Technical Rationale for Reliability Standard

PRC-028-1

PRC-028-1 – Disturbance Monitoring and Reporting Requirements for Inverter Based Resources

Figure 1: Typical ~~IBR Inverter-based Resource Generating Facility~~ Single Line Diagram

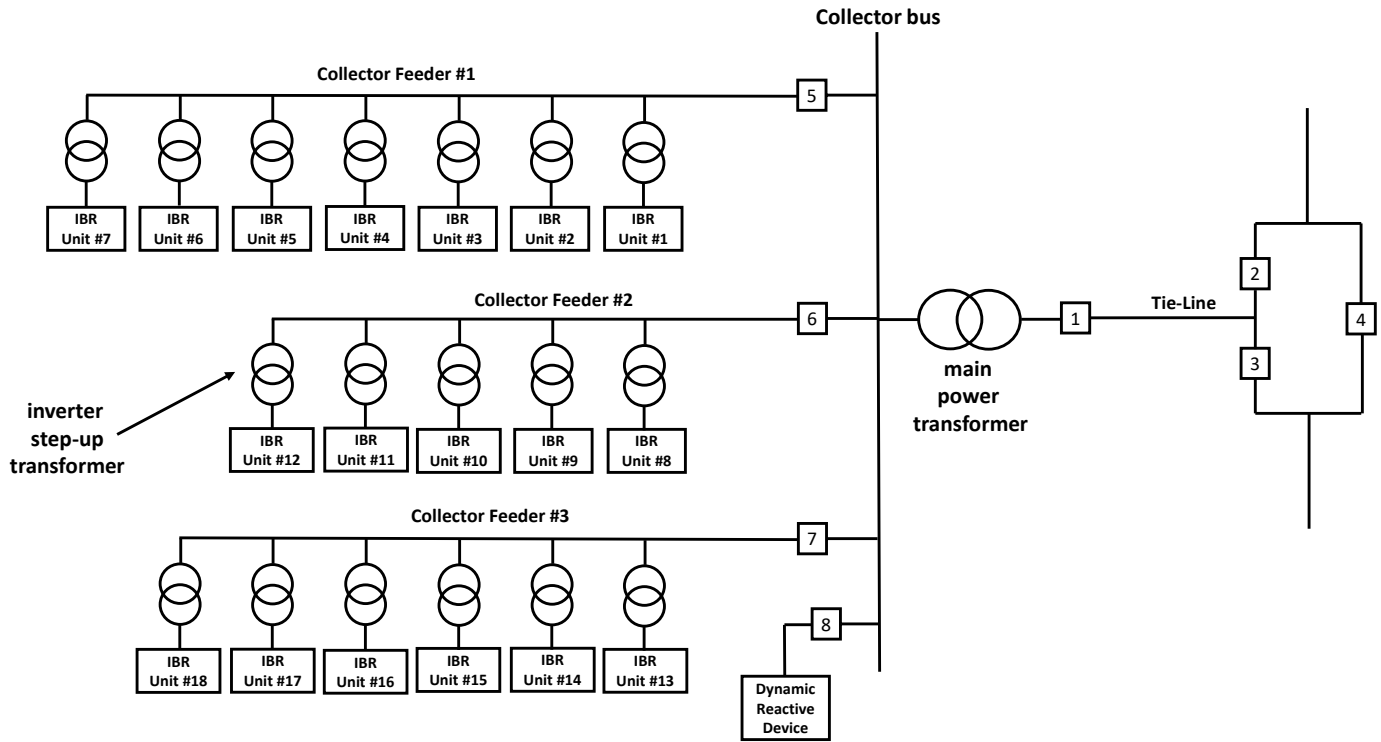
~~#7 are connected to collector feeder #1 at 2800 ft and 3000 ft distance from the collector bus respectively. IBR Unit #18 is connected to collector feeder #3 at 2800 ft distance from the collector bus. In other words, these IBR Units #6, #7 and #18 are connected at a distance $\geq 90\%$ of the longest collector feeder from the collector bus. This IBR inverter-based resource generating facility is equipped with a dynamic reactive device (e.g., synchronous condenser, static VAR compensator etc.) connected to the collector bus.~~

SER Data: The SER data is required for circuit breaker 1, 5, 6, 7, and 8. Circuit breaker 1 is associated with the main power transformer. Circuit breakers 5, 6, 7, and 8 are associated with the collector bus. ~~The SER data for IBR Unit #6, #7, or #18 is required as these are connected at a distance $\geq 90\%$ of the longest collector feeder from the collector bus.~~

DDR Data: The DDR data is required from high side terminals of the main power transformer. If the inverter-based resource ~~IBR plant~~ consists of more than one main power transformer, then DDR data for each main power transformer is required. ~~The DDR data from individual IBR Units is not required.~~

Figure 2: Typical inverter-based resource ~~IBR Generating Facility~~ with two collector buses and main power transformers

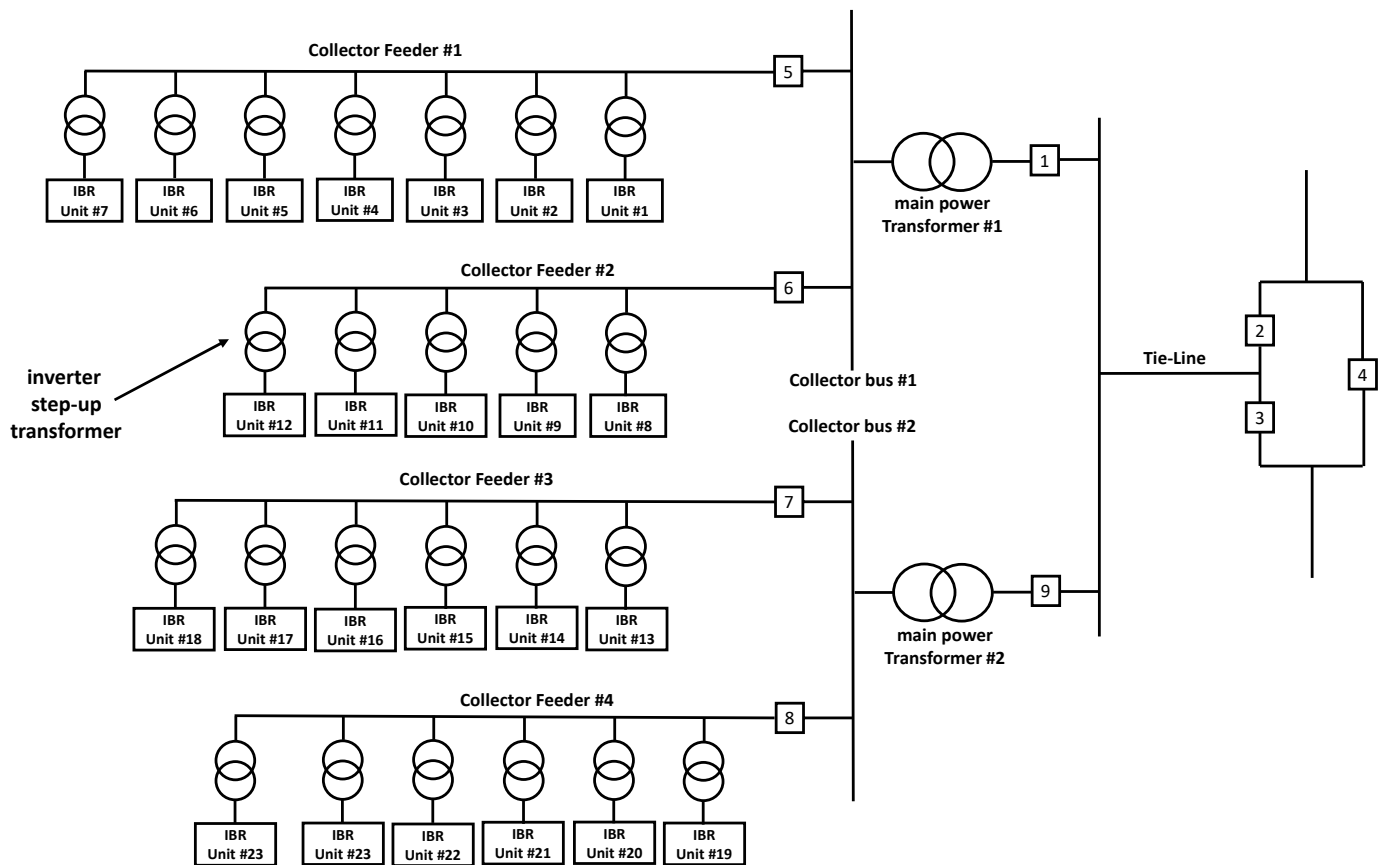
SER Data: The SER data is required for circuit breaker 1, 5, 6, 7, 8 and 9. Circuit breakers 1 and 9 are associated with main power transformers. Circuit breakers 5, 6, 7, and 8 are associated with collector buses #1 and #2. ~~The SER data for IBR Unit #6 or #7 is required as these are connected at a distance $\geq 90\%$ of the~~

~~longest collector feeder from the collector bus #1. The SER data for IBR Unit #17, #18, or #23 is required as these are connected at a distance $\geq 90\%$ of the longest collector feeder from the collector bus #2.~~

~~**FR Data:** The FR data is required from high side terminals of both main power transformers. The SER data for IBR Unit #6 or #7 is required as these are connected at a distance $\geq 90\%$ of the longest collector feeder from the collector bus #1. The SER data for IBR Unit #17, #18, or #23 is required as these are connected at a distance $\geq 90\%$ of the longest collector feeder from the collector bus #2.~~
